**RE: Tucson South Resource, M-2004-044, Amendment Number 1 (AM01)
Adequacy Review No. 2**

Enclosure: *Memorandum, Adequacy Review of Exhibit 6.5 – Geotechnical Stability Adequacy Response
Aggregate Industries; Tucson South Resource; File No. M-2004-044; AM0, Dated July 25, 2019*

**Re: Adequacy Review of Exhibit 6.5 – Geotechnical Stability Adequacy Response
Aggregate Industries; Tucson South Resource; File No. M-2004-044; AM-01**

Project Tucson South AM
F-2 - Pseudostatic - Fill

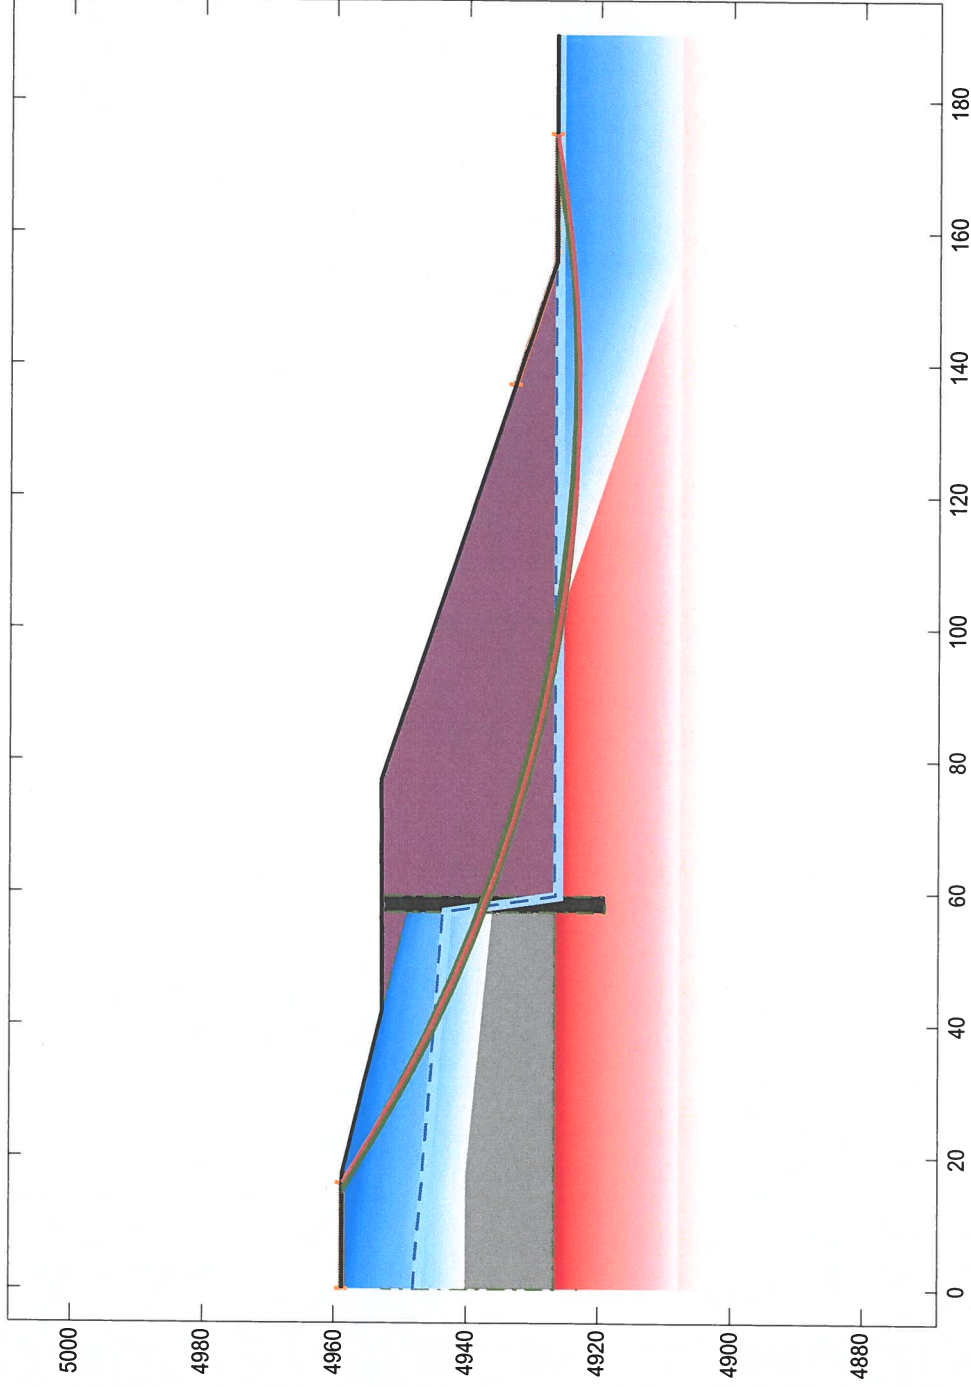
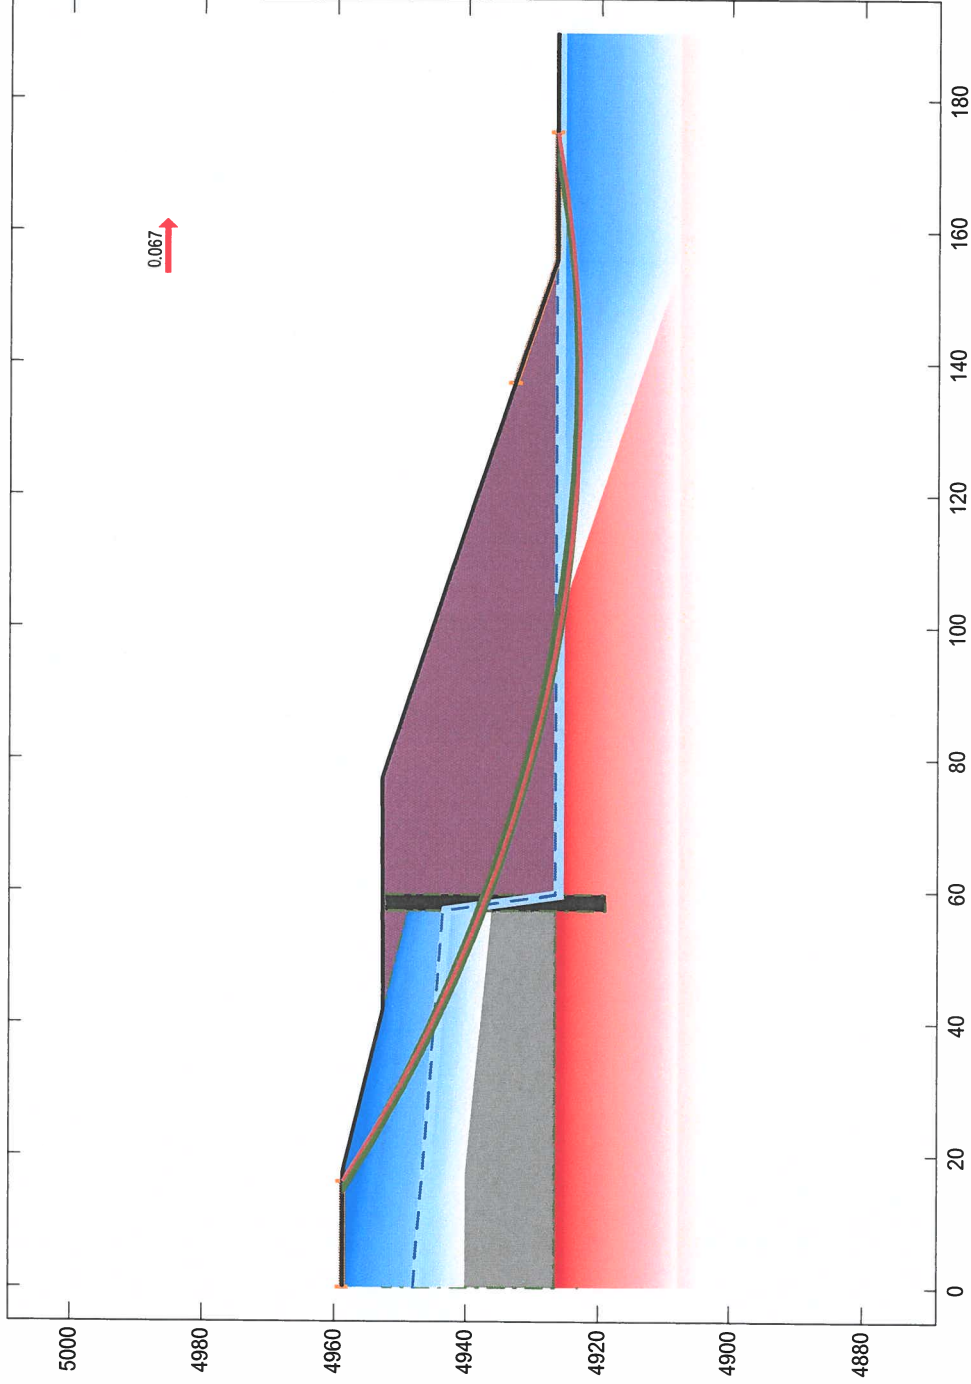
3. The Applicant modeled the Figure F analysis with a 35 feet offset from the power pole easement to the top of the mine slope. The Exhibit C-3 Map indicates the Applicant modeled a 45 feet offset. Please explain this discrepancy and revise the Figure F models and/or the Exhibit C-3 Map accordingly.

Project Tucson South AM
G-2 - Pseudostatic - Fill

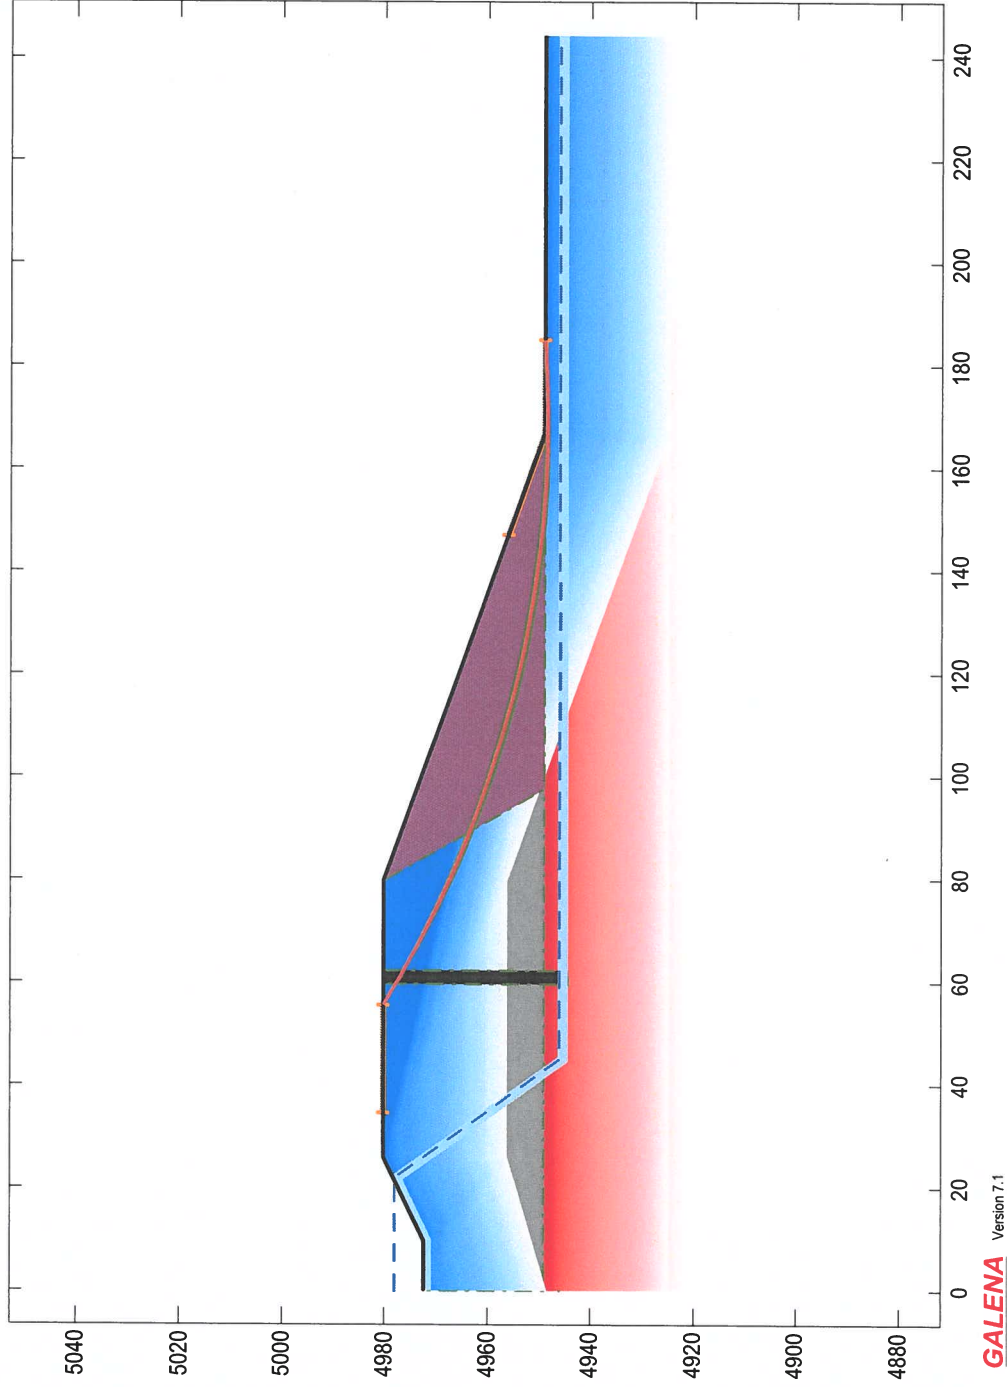
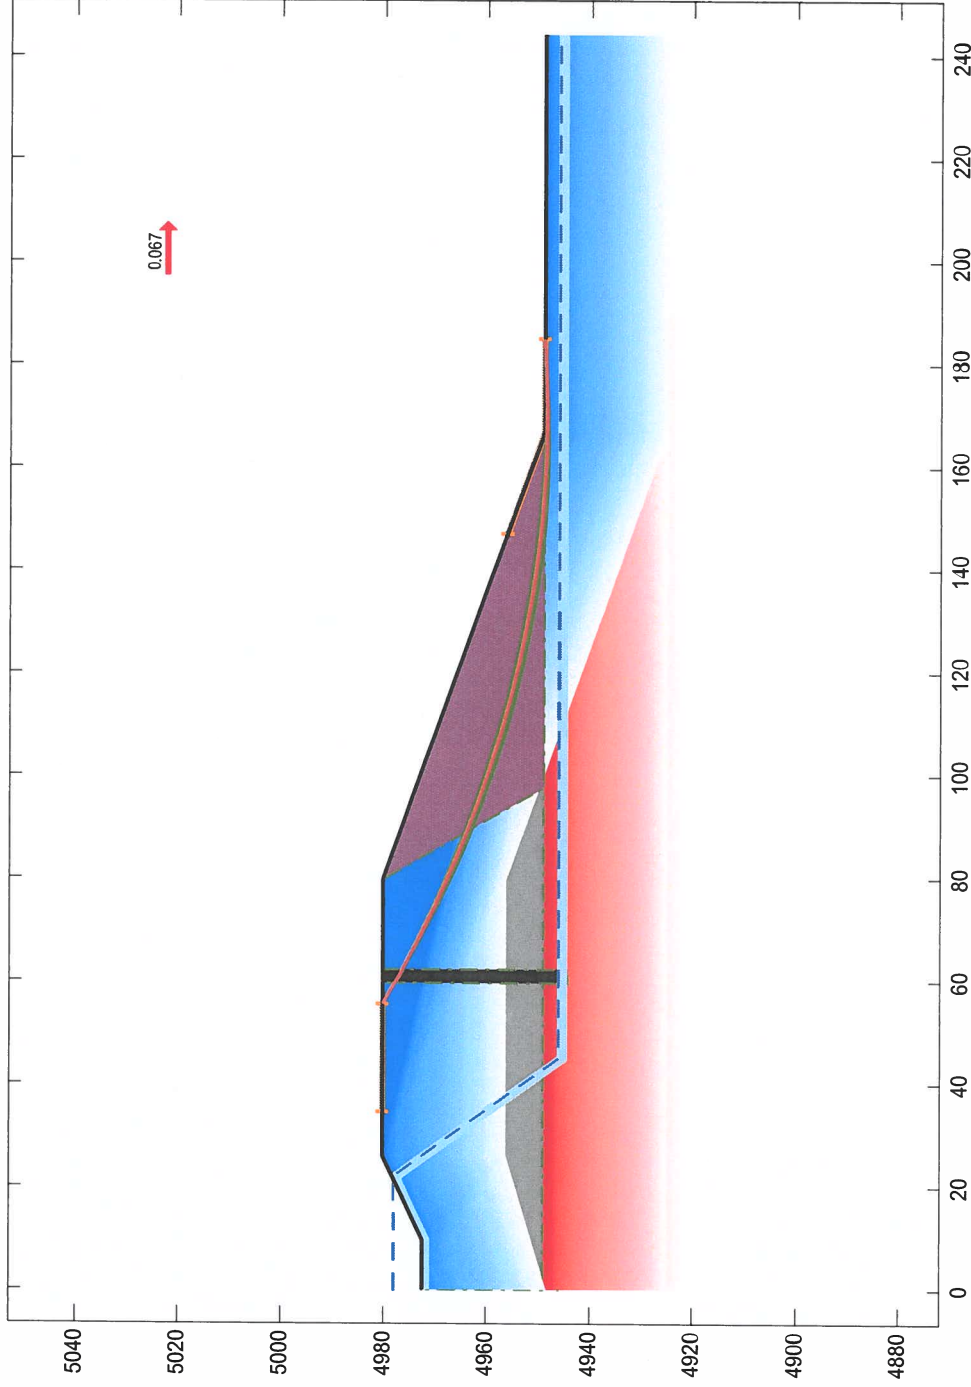
4. The Applicant modeled the Figure G analysis with a 53 feet offset from the Brighton Ditch to the top of the mine slope. The Exhibit C-3 Map indicates the Applicant modeled a 35 feet offset. Please explain this discrepancy and revise the Figure G models and/or the Exhibit C-3 Map accordingly.

Project Tucson South AM
H-1 - Static

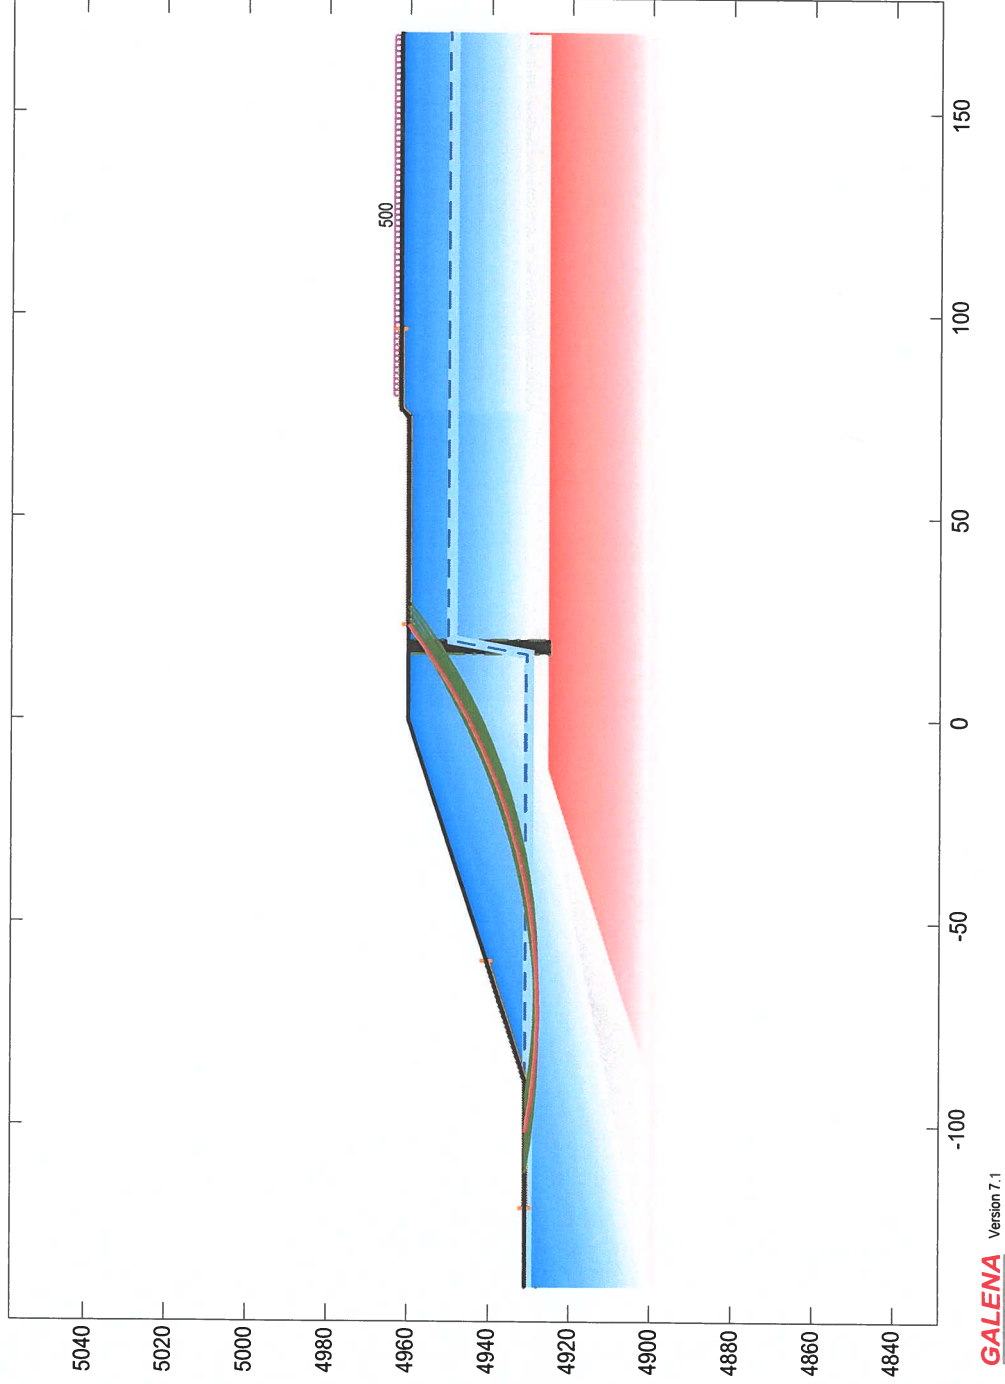
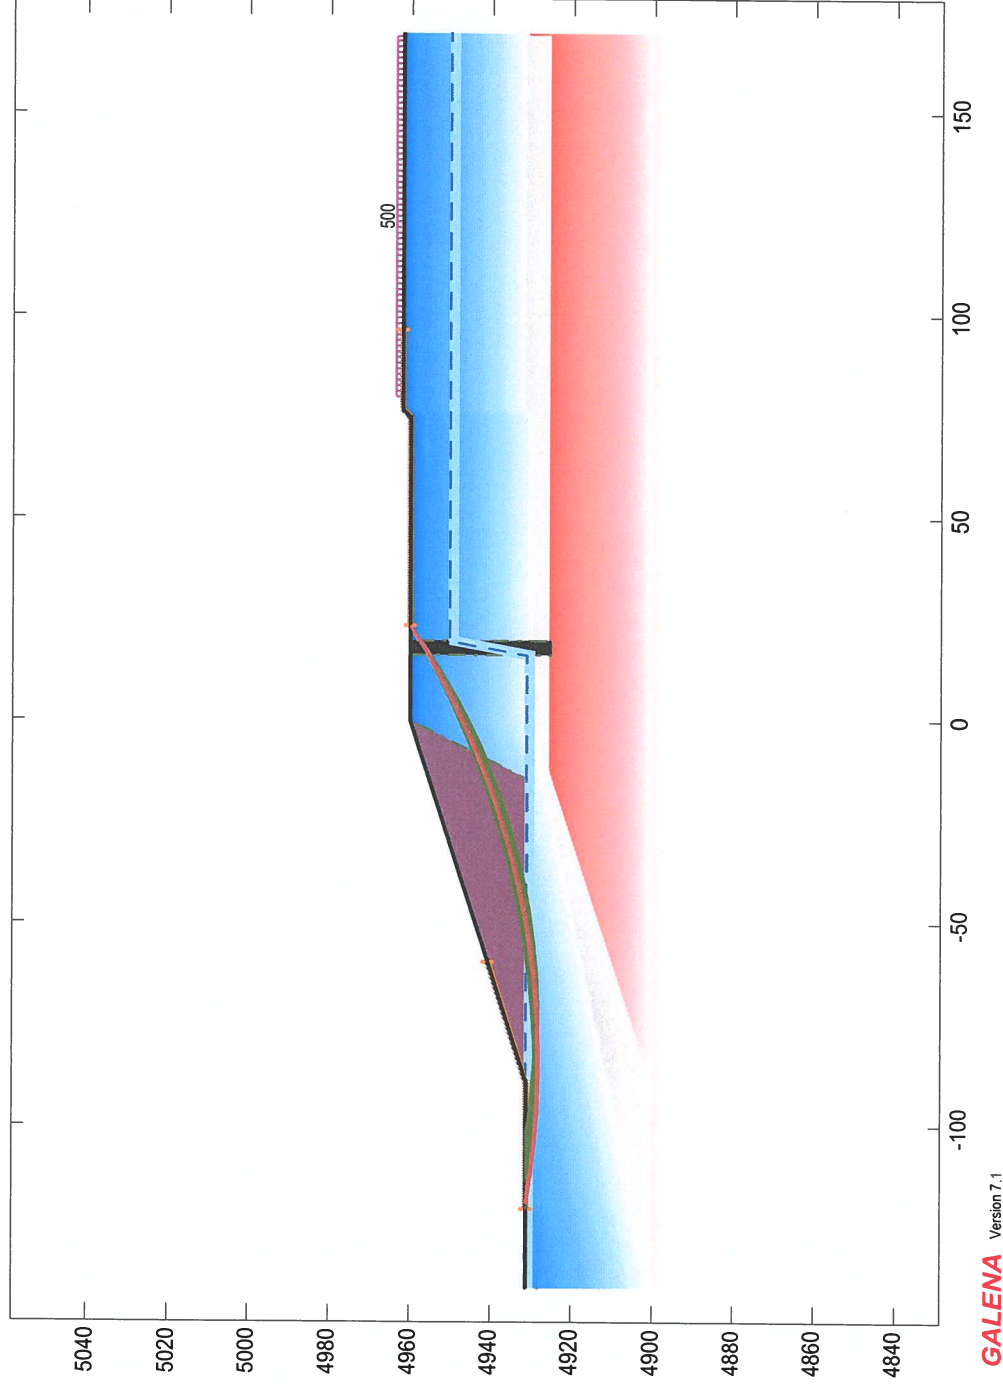
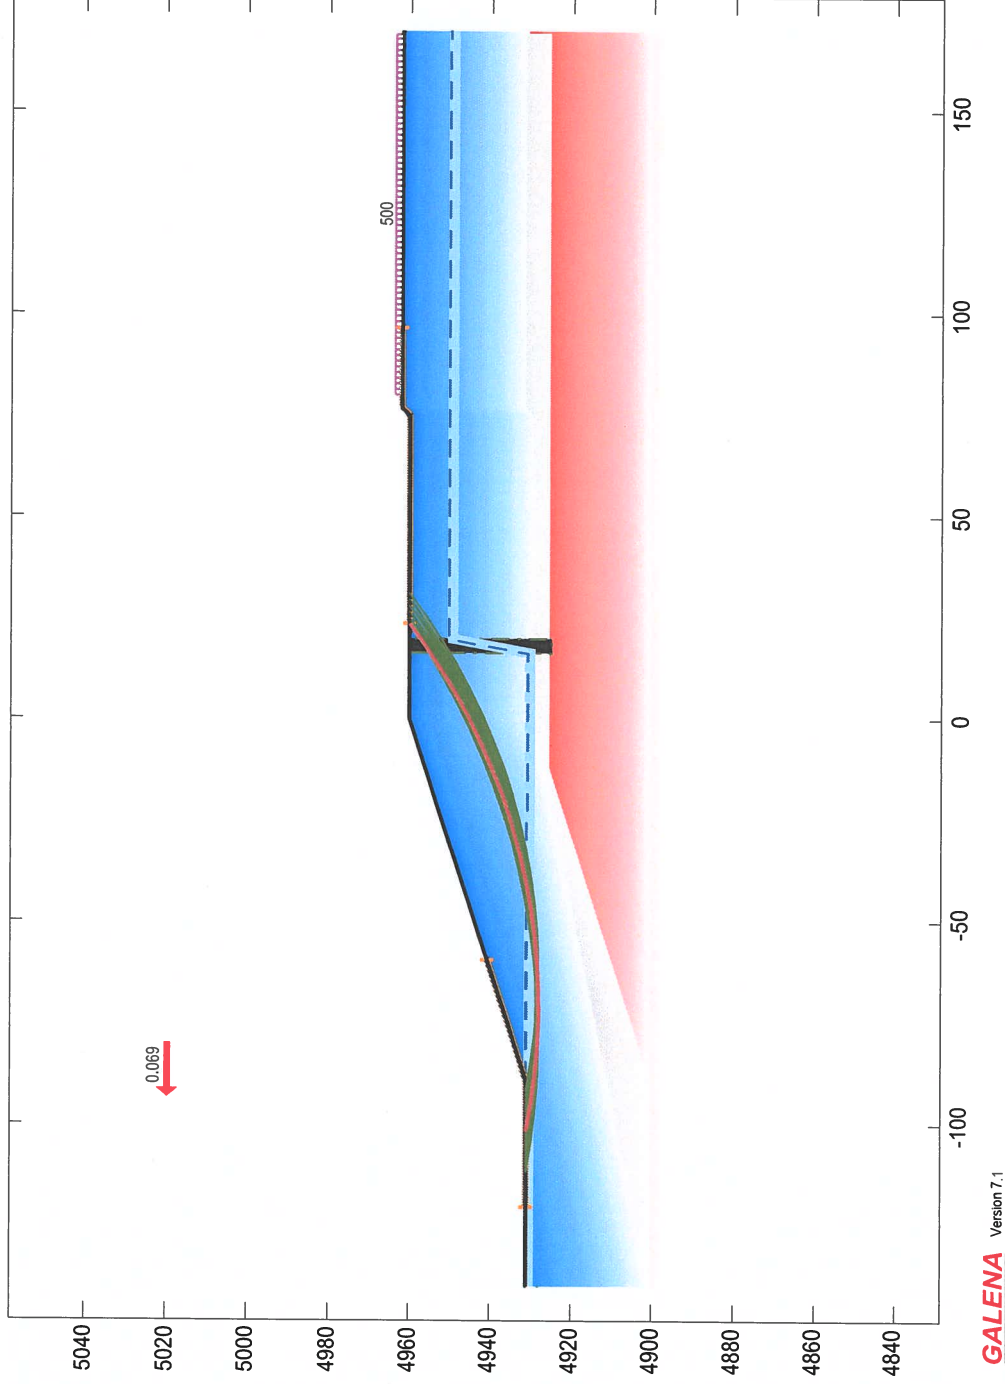
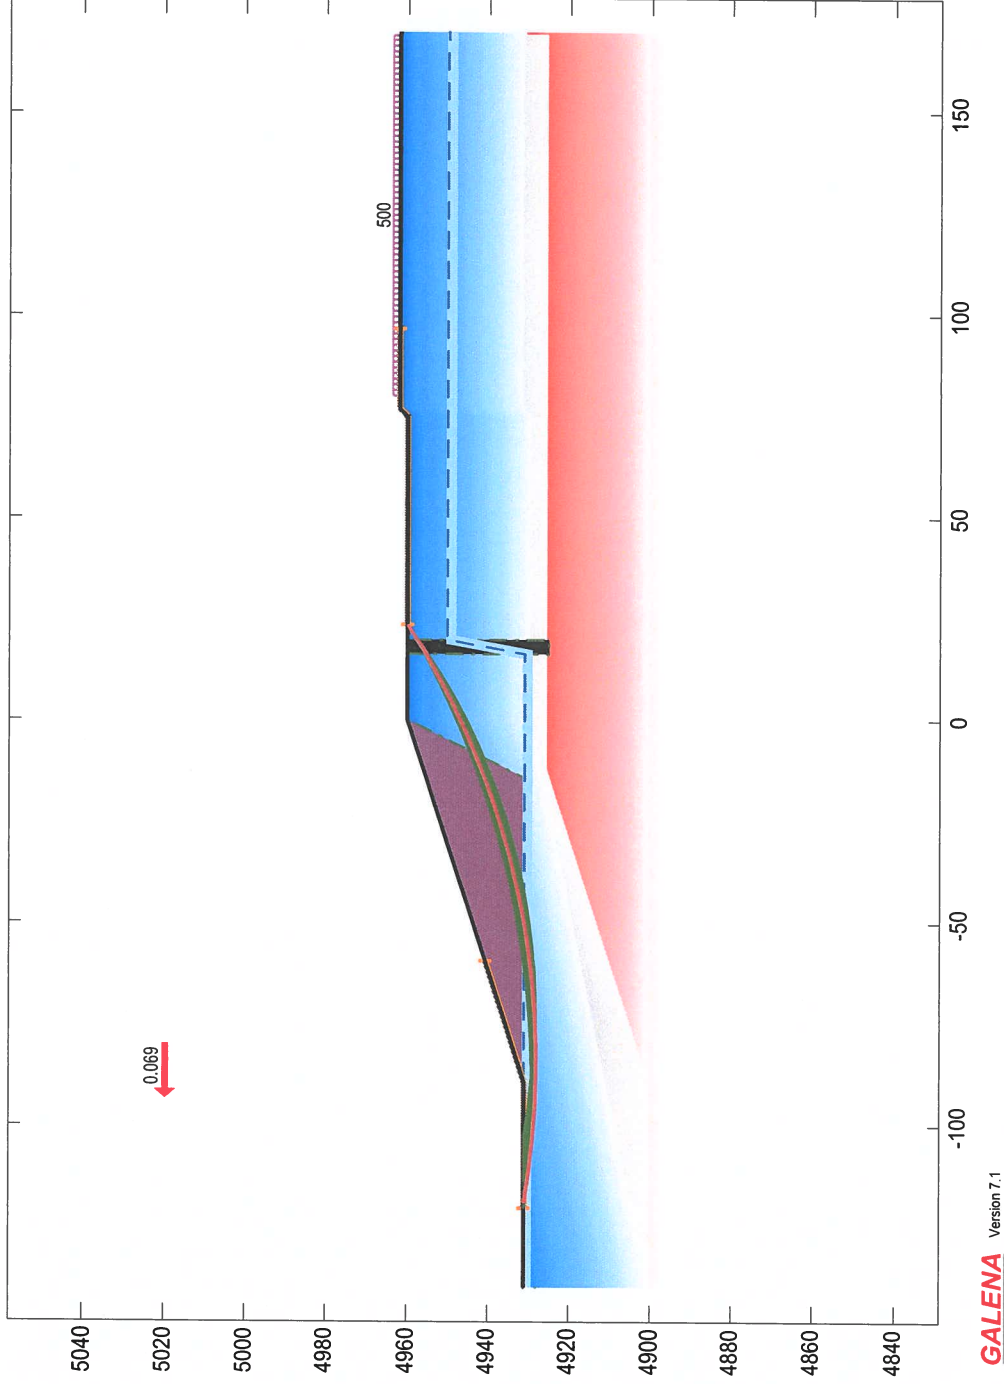
5. The Applicant modeled the Figure H analysis with a 75 feet offset from the edge of Highway 7 to the top of the mine slope. The Exhibit C-3 Map indicates the Applicant modeled a 106 feet offset. Please explain this discrepancy and revise the Figure H models and/or the Exhibit C-3 Map accordingly.
